# **HOSHIZAKI AMERICA, INC.**

## **SERVICE BULLETIN**

**SB92-0001**

**SUBJECT: WIRING DIAGRAMS FOR ALPINE BOARD UNIT**

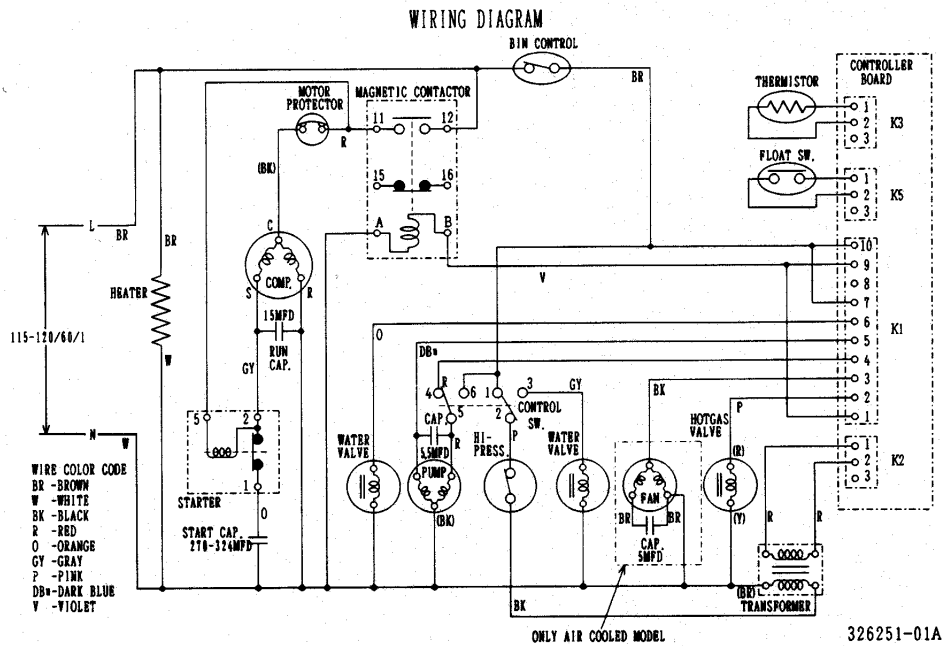
With the change to the domestic Alpine control board, you will find that the wiring diagrams have changed. The protect relay is eliminated due to internal safeties in the transformer and the cleaning valve interlock switch is added. The Alpine board is easily distinguishable by the red connector, (which is not used) and the eight dip switches. The Alpine board wiring diagram is also very distinguishable because the K2 connector for the transformer is shown at the bottom of the control board and it contains no protect relay.

Included in this bulletin you will find Alpine wiring diagrams for all KM models. Please update your Service Manuals and Service Keys with these new drawings.
